PLANNING AND ACCESS COMMITTEE

SUBMITTED BY:	Head of Planning & Rural Development
APPLICATION NUMBER:	2017/0111/DET
APPLICANT:	Mr Robert Stevenson, AR Hospitality
LOCATION:	Bridge Of Lochay Hotel, Killin Stirling FK21 8TN
PROPOSAL:	Erection of dwellinghouse

Figure 3. Site Plan (proposed)

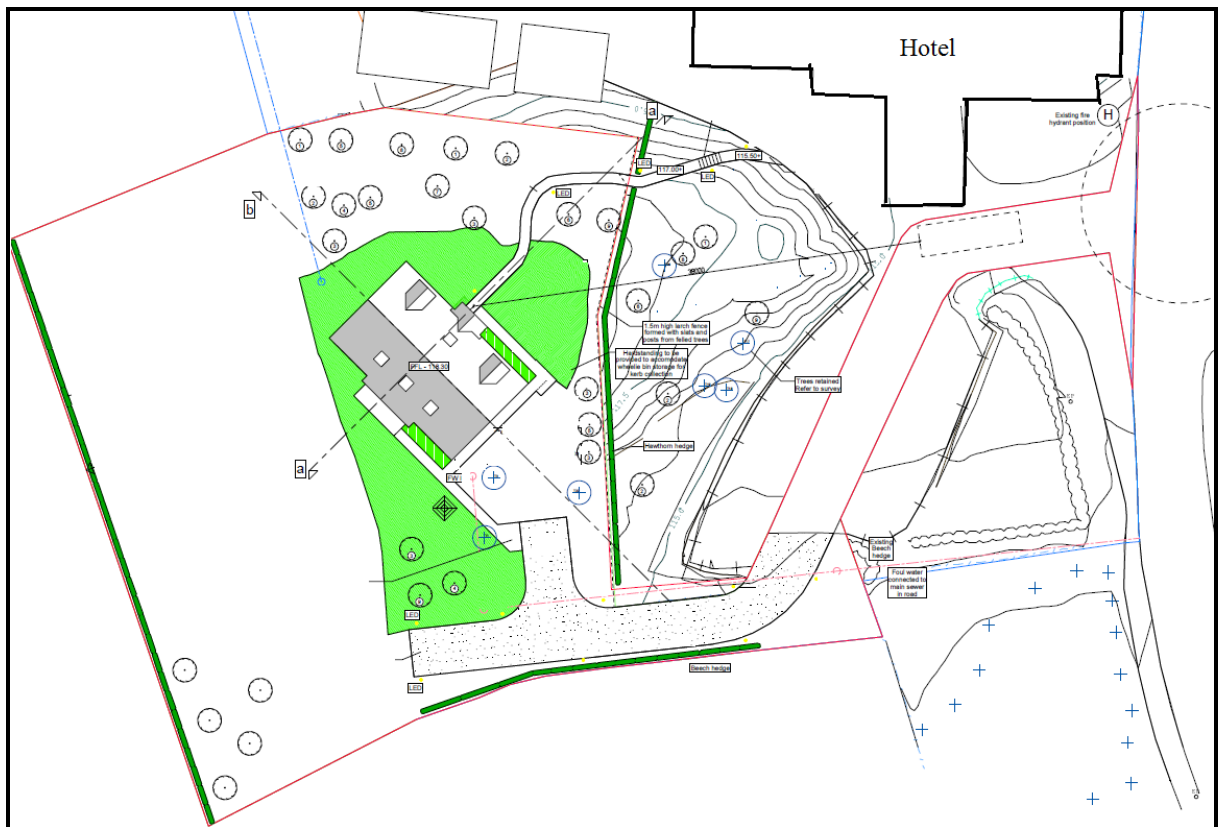
- 7.9 The site layout plan has changed several times through the processing of the application. The final version includes a detailed landscaping scheme with planting schedule and planting methodology. The NP Trees and Woodlands adviser notes that the several tree species would not be appropriate and should be replaced, which can be required by condition. The commitment to remove non-native shrubs is welcomed and a condition would be required to remove any regeneration of *Rhododendron ponticum* which may occur on the site for the next 5 years (see condition 4).

4. **Details of Landscaping:** Prior to the commencement of development on site a revised 'Site Plan – Landscaping' drawing shall be submitted to and approved in writing by the Planning Authority. The said scheme/plan (at a scale of 1:500 or greater) shall include the details shown on drawing reference 11533-12 Rev F, with the following changes:

- Deletion of *Alnus incana* and *Viburnum opulus* (*Alnus glutinosa* and *Prunus padus* would be acceptable substitutions)
- A commitment to remove any regeneration of *Rhododendron Ponticum* which occurs on the site for the next 5 years.

Figure 4. Elevations

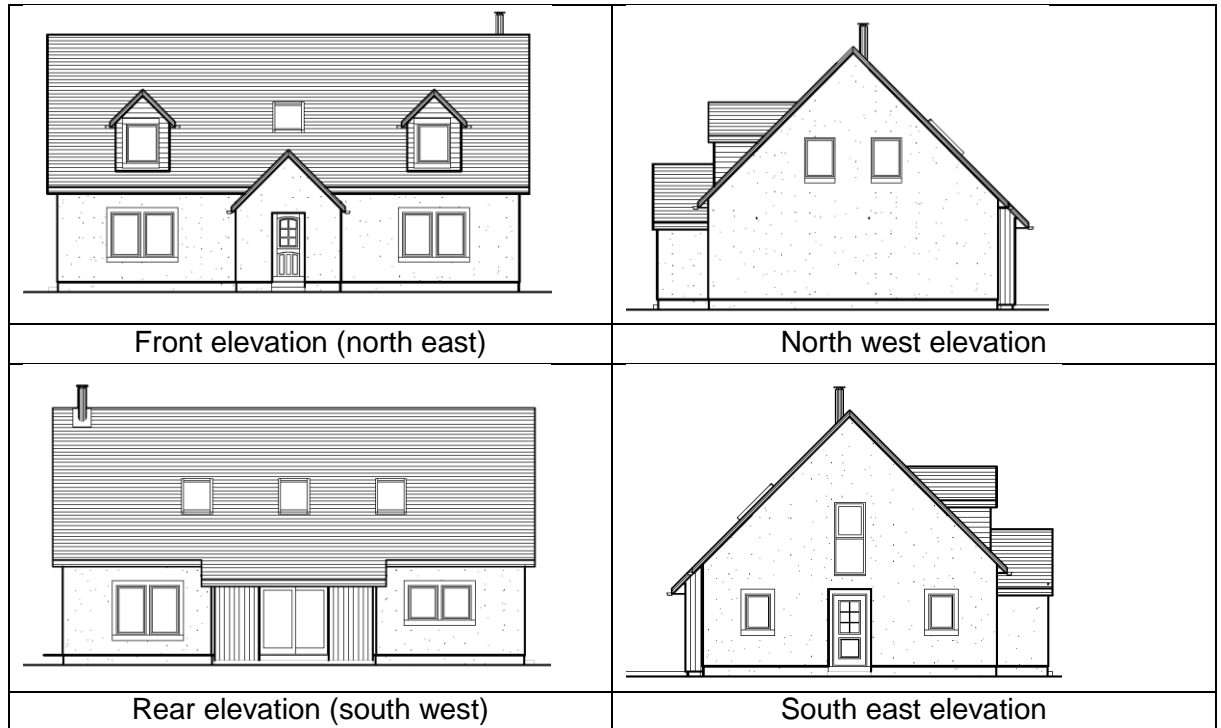
- 7.5 The concept and materials for the proposed house – a 1.5 storey traditional house with natural slate roof, white wet dash render to walls, timber windows and black gutters and downpipes is in accordance with the Supplementary Guidance on Design and Placemaking, however a few design changes were requested by the case officer in the processing of the application. The original plans showed a chimney which was not flush with the gable and in revised plans submitted by the agent (see section 3.3 above) this was replaced by a small flue. The initial

dormer proportions were large and dominating and these were reduced in size and a central rooflight added. Original plans included an off-centre front door. This was centralised to improve symmetry within a new front porch.
